Access Compliance Report

Public Rights-of-Way

Intersection ID: 44484	Main Street: FINN_HALL_AV	Cross Street: NEWFIELD_ST	Location:	N
ADA ID: 755EC2D7C9A7	Ramp Type: Perp	Initial Pass/Fail: Fail	Overall Compliance: No	Severity Score: 8.75
Codes/Mitigation Info/Possible Solution		Field Measurements/Component Compliance

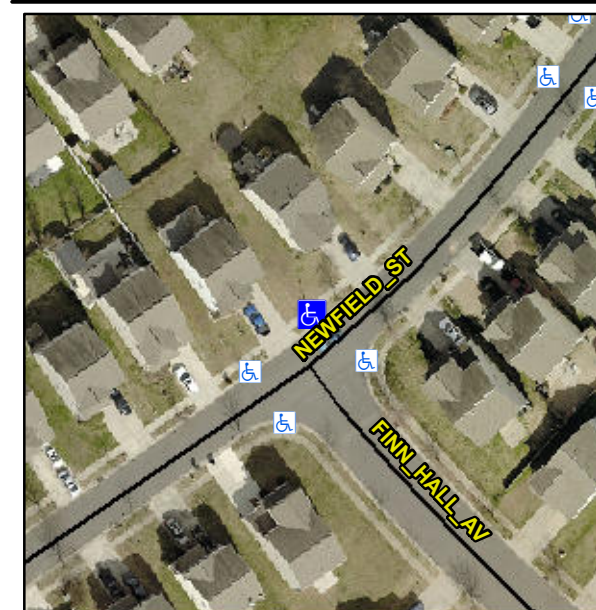
Remove & Replace Entire Ramp.

Not Found, R304.5.1
